CIRCULAR ATTACHED TO AD 364 (issue 1)

AIRWORTHINESS DIRECTIVE

SUBJECT: Modification of Gadringer FB19 Harness Buckle, Tongue Half, to prevent failure to release under emergency conditions.

GFA AD 364	Issue 1	4/8/1989	Sheet 2 of 6
------------	---------	----------	--------------

Figure 1

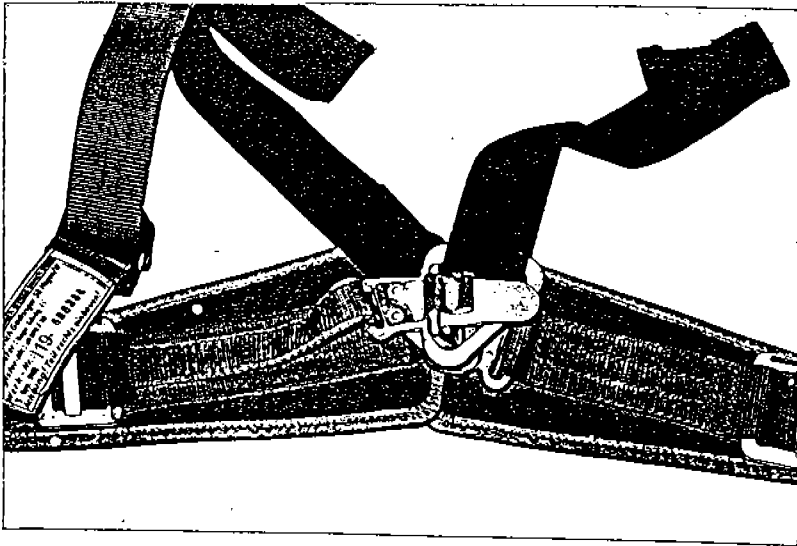
- * Over recent years, many pilot harness assemblies have been subject to renewal of harness straps, replacement of abdominal pads and other repairs and miscellaneous modifications, dictated by age, condition and the high cost of new harness assemblies.
- * Repair and refurbish work has been completed by a wide range of organizations and individuals not all of whom have followed G.F.A. harness repair guidelines, or requested G.F.A. design approval for non standard repairs and modifications.
- * The original Gadringer harness system, fitted with the FB 19 Buckle was fitted with two, large, abdominal support pads which are shown in Figure 1.

These two pads not only provided good abdominal support THEY ALSO PREVENTED THE TWO BUCKLE HALVES ENGAGING TOO FAR, THEREBY PREVENTING THE TWO HALVES JAMMING TOGETHER.

Figure 2

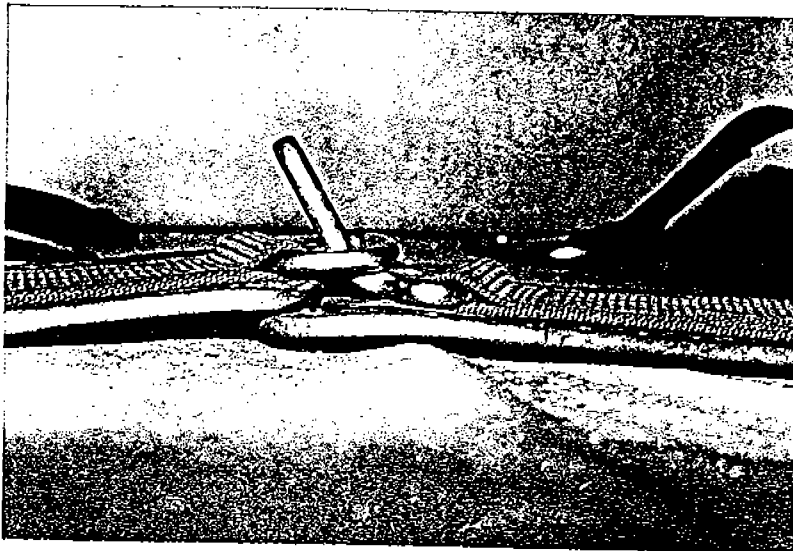
- * The fit of the buckle halves with the correct, original pads is shown in figures 2 and 3. The pad overlap and their stiffness ensuring correct buckle alignment
- * Some refurbished harnesses have no abdominal pads at all. Some have small pads as shown in Figure 4 which do not support or align the buckle halves correctly.
- * Some original Gadringer harness assemblies may be in service with no abdominal pads, the original pads being removed because of deteriorated condition .

Shows the pad overlap and the correct fit of the two buckle halves. The "bend up" angle of the tongue is obviously important

Figure 3

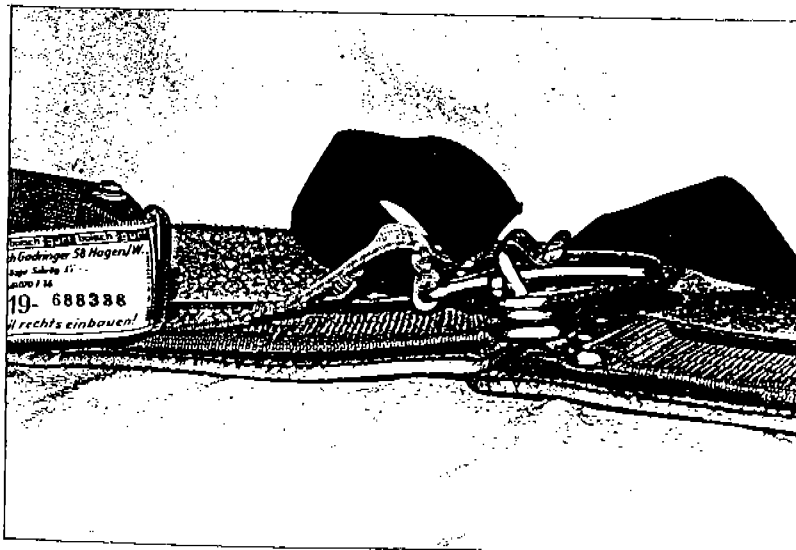
Shows pad overlap and all four straps correctly assembled with proper alignment controlled by the pads.

Figure 4

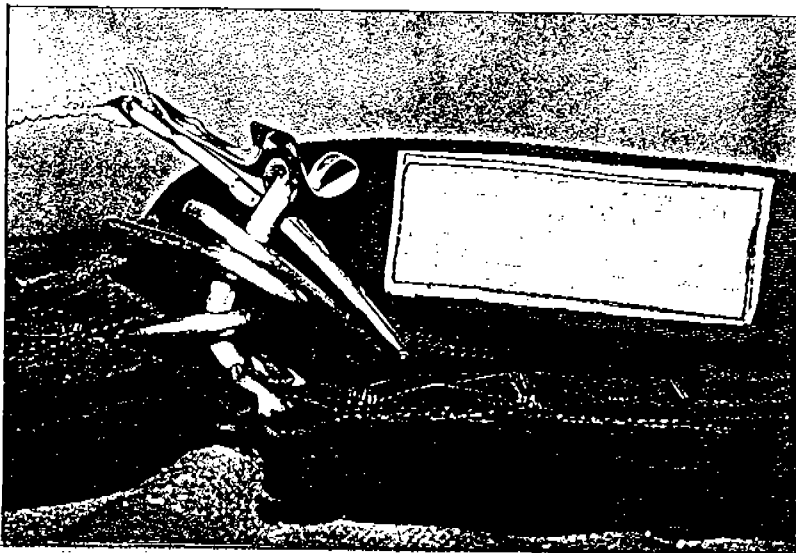
These 2 illustrations show that without correct pad support the two lap strap buckle halves can engage too far and hook by jamming together at an angle that prevents self disengagement

Figure 5

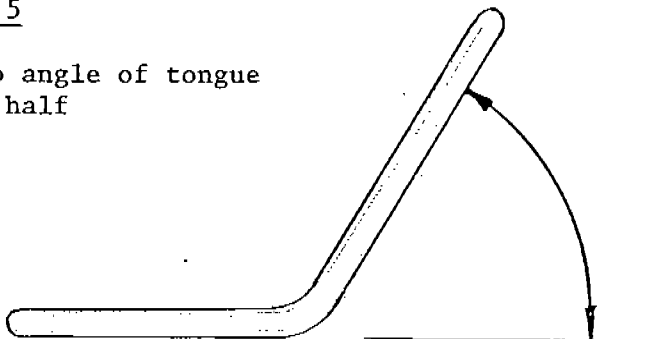
- * Some ORIGINAL Gadringer harnesses still in service may have ORIGINAL abdominal pads which are in such poor condition they may no longer prevent jamming of the two buckle halves.
- * The harness involved in the above incident displayed a considerable change in the bendup angle of the buckle tongue. This may have been damage incurred during the accident or may have been man made at sometime in the past.

ANY CHANGE IN THIS ANGLE WILL AFFECT THE EASE OF DISENGAGEMENT OF THE TWO BUCKLE HALVES.

This is illustrated in Figure 5.

- (1) Inspect all pilot harness assemblies for the presence of Gadringer buckle tongue half FB19. ALL buckle halves found to then be subject to the following inspection and modification.
- (2) Inspect the FB19 buckle tongue half for condition and the correctness of the bendup angle (reference Figure 5)
- (3) If either the condition of the buckle tongue half is unacceptable or the bendup angle is outside the tolerance stated, the component is to be removed and destroyed.

Bend up angle $57^\circ \pm 2^\circ$ measured at 90° to the tongue fold line.

APPENDIX A BUCKLE MODIFICATION

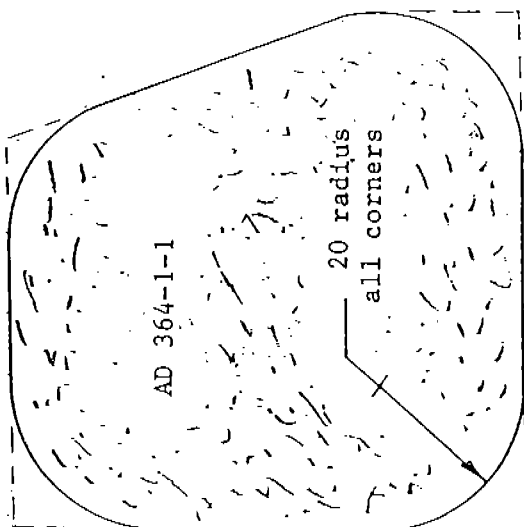
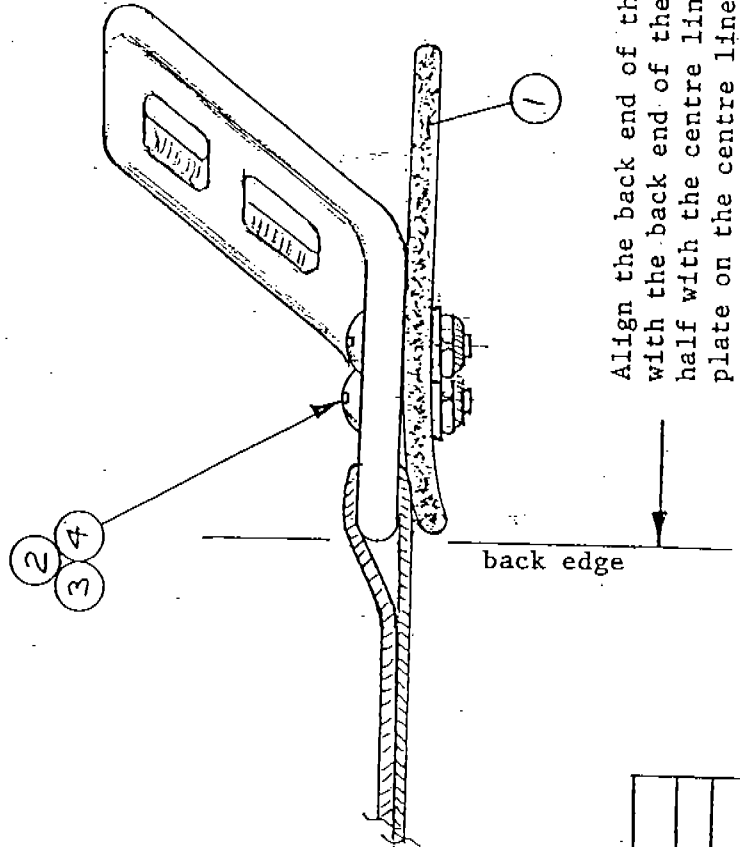
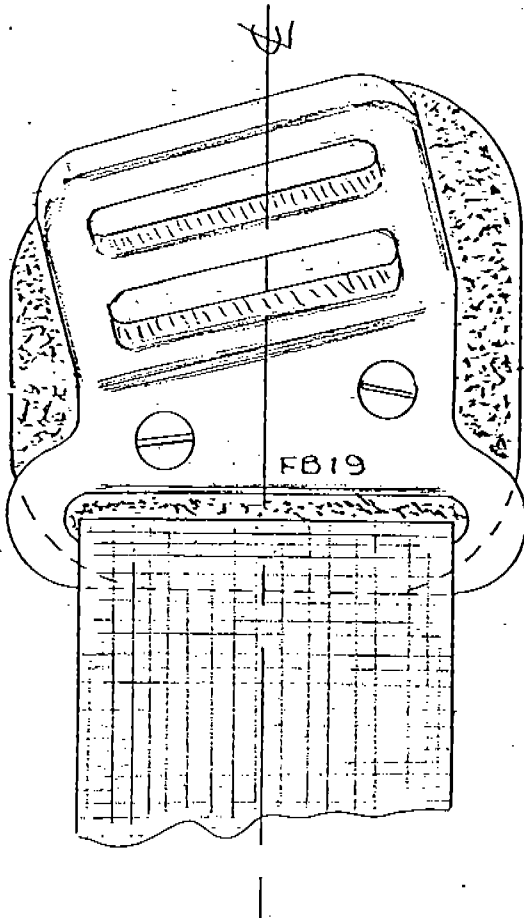
The modification to Gadringer Buckle Tongue Half (ident. FB19), fully detailed in APPENDIX A will prevent jamming of the two buckle halves irrespective of the condition or existence of abdominal support pads, provided the following actions are taken.

- (4) If the buckle tongue half inspects O.K. then the modification involving the installation of a fixed plate as detailed in Appendix A is to be carried out before the above date.

- 1 PLATE supplied with square corners, to be finished to the instructions on Page 6

Align the back end of the Plate with the back end of the buckle half with the centre line of the plate on the centre line of the webbing.

- * Remove the original rivets, carefully without damage to the buckle half.
- * Locate the plate (before rounding the square corners) with its back edge aligned with the buckle half back edge, the center of the plate aligned with the center line of the webbing and drill through the existing rivet holes using a 1/8 inch dia drill.

- * Open up one hole through the buckle half and plate using a 9/64 inch dia drill.
- * Fit one screw/nut/washer through that hole, tighten and check the fit and alignment of the plate. If that is satisfactory back drill the other hole and fit the second screw.

- * Disassemble the plate, round off the corners with a 20 mm radius and remove all other sharp edges (appearance, plus we must avoid abrading the webbing)

- * Finally fit the plate with the screws/nuts/washers supplied ensuring that the textured side of the plate is AWAY FROM THE BODY.
- * The ends of the screws may be filed flush with the end of the nuts to avoid any abrasion on clothing etc.

If the harness has original Gadringer abdominal straps in good condition they should be left in place, their attaching rivets removed and the above modification completed. The pad can then be contact glued to the underside of the new plate after opening out the rivet holes through the padding to accept the nuts securing the plate.
